## COUNCIL ASSESSMENT REPORT

<b>Panel Reference</b>	2017SNH051
<b>DA Number</b>	DA-2017/157
<b>LGA</b>	Willoughby City Council
<b>Proposed Development</b>	New commercial tower – construction of sixteen (16) storey commercial building, plaza, landscaping, car parking and associated works ( <b>Revised Scheme</b> )
<b>Street Address</b>	67 Albert Avenue, Chatswood NSW 2067
<b>Applicant/Owner</b>	CorVal Partners Limited / Willoughby City Council
<b>Date of DA lodgement</b>	12 May 2017
<b>Number of Submissions</b>	19 submissions and 3 petitions (totalling 565 signatures)
<b>Recommendation</b>	Deferred Commencement Consent
<b>Regional Development Criteria (Schedule 7 of the SEPP (State and Regional Development) 2011)</b>	n/a
<b>List of all relevant s4.15(1)(a) matters</b>	Willoughby LEP 2012; Deemed SEPP–Sydney Harbour Catchment 2005; Willoughby DCP 2017 (WDCP); Chatswood Central Business District S94A Plan.
<b>List all documents submitted with this report for the Panel's consideration</b>	Supplementary Report to Amended Plans in response to SNPP Deferral Revised Schedule of Conditions Applicants Response to Deferral Revised Architectural Plans Supplementary Reports

Panel Ref: 2017SNH0

**Figure 1** – Extract from *Stamford Property Services Pty Ltd v City of Sydney & Anor [2015] NSWLEC*

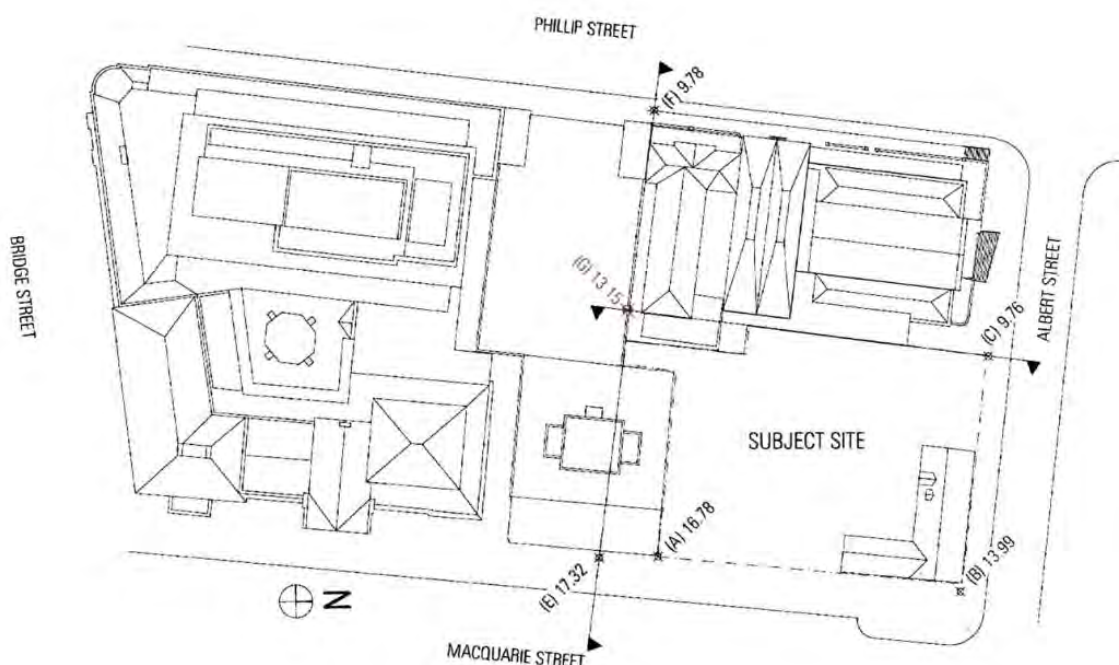
The existing ground level beneath and surrounding the proposed development is heavily modified, as such is it not possible to accurately survey the existing ground level beneath each point within the footprint of the proposed development. *Stamford Property Services Pty Ltd v City of Sydney & Anor [2015] NSWLEC 1189* is instructive in determining how the existing ground level should be measured in cases such as this as it is more recent and builds on the principles established in *Bettar v Council of the City of Sydney [2014] NSWLEC 1070*. In paragraph 288 of this judgement, Pearson C and Smithson AC note the following:

*...we are satisfied that there is sufficient information to determine “ground level (existing)” for the site, and we agree with Ms Robinson and Mr Chambers that the definition is workable. That is in fact demonstrated by the plan provided by Mr Harrison (Ex G, Figure 1) (refer to **Figure 1**) showing measurement of average boundary levels based on actual and surveyed levels in the public domain, with a figure in the centre of the site being an average between two surveyed points rather than a surveyed ground level:*

Consistent with the approach suggested in this case by Mr Harrison, and agreed by Pearson C and Smithson AC, Fitzpatrick and Partners have provided two surveyed ground levels adjacent to the proposed building to determine the existing ground level on the western side of the proposed building. To determine the existing ground level at the eastern side of the building, surveyed levels have been obtained on Victor Street, the existing ground level on the west of the site can then be demonstrated to be the pro-rata average of two surveyed points. This is illustrated below in **Figure 2**.

**Figure 3** – morning shadow impact at Spring and Autumn equinox

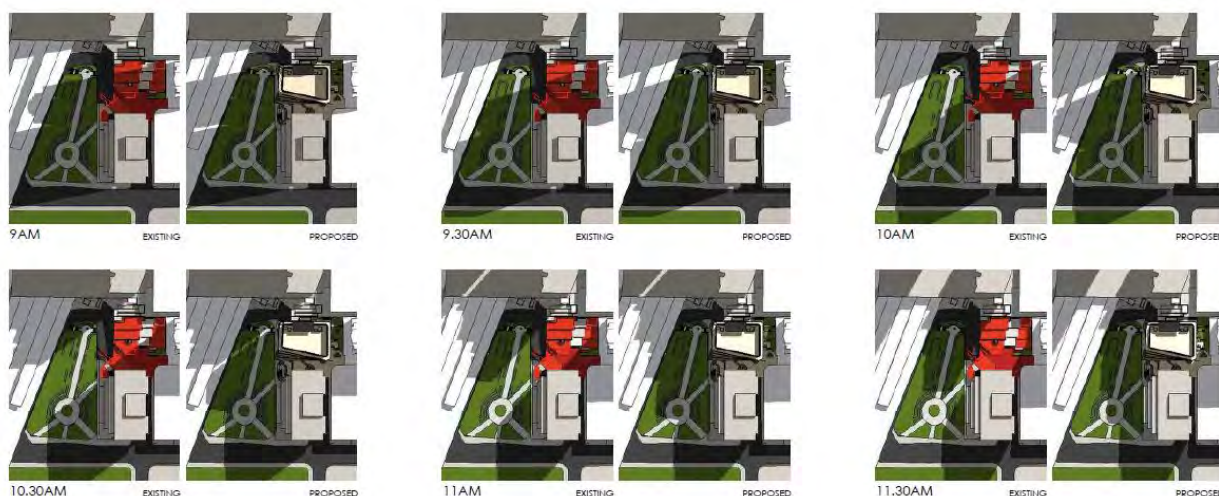
- Additional overshadowing analysis undertaken at the request of the Panel for both equinoxes demonstrates that, consistent with the impact of the building in mid-winter, the impact of the building at the spring and autumn equinoxes will introduce additional overshadowing to the gardens between 9am and 12 noon but will have no impact on the gardens after this point. Extracts are provided below as **Figure 3**, and **Figure 4**.

**Figure 4** –shadow impact at mid winter

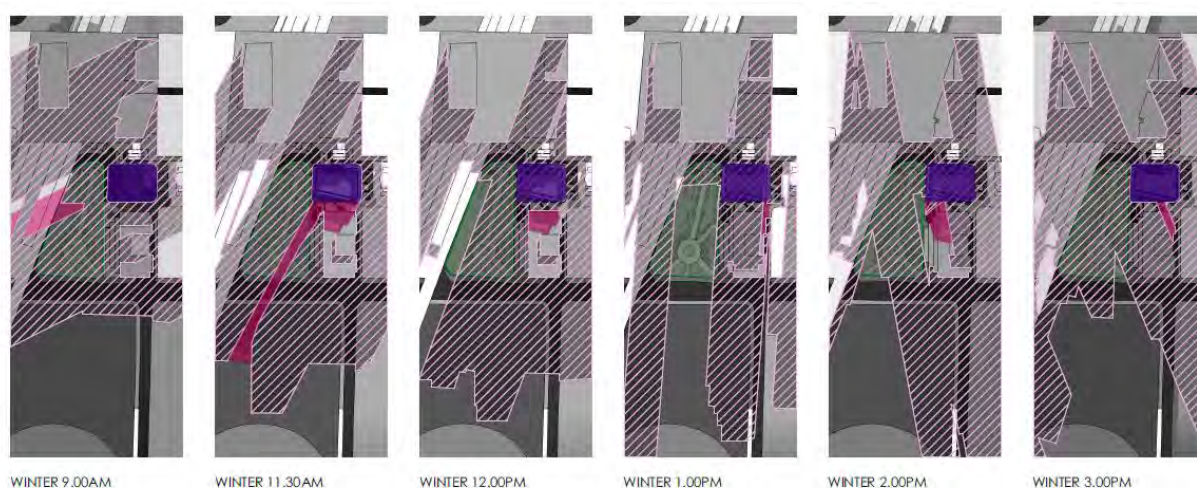
- No additional overshadowing of the Gardens of Remembrance is introduced within the window for which additional overshadowing is prohibited by the provisions Clause 4.3A(8) of the WLEP (being at mid-winter between 12.00 pm and 2.00 pm).

- The expert advice of a consulting Rosarian was sought by the proponent to assist in assessing the relative importance of the additional overshadowing impacts on the overall health of the roses. The Rosarian reported informally that due to the complex and multiple variables that influence the health of rose plants (including soil conditions, sunlight, plant diseases, temperature, weather and moisture levels etc), it is difficult to conclusively ensure the survival of the roses within the Garden of Remembrance. Despite this, the rosarian was able to determine that the most shadow-impacted roses within the Garden are unlikely to become unhealthy due to the reduction in solar access.
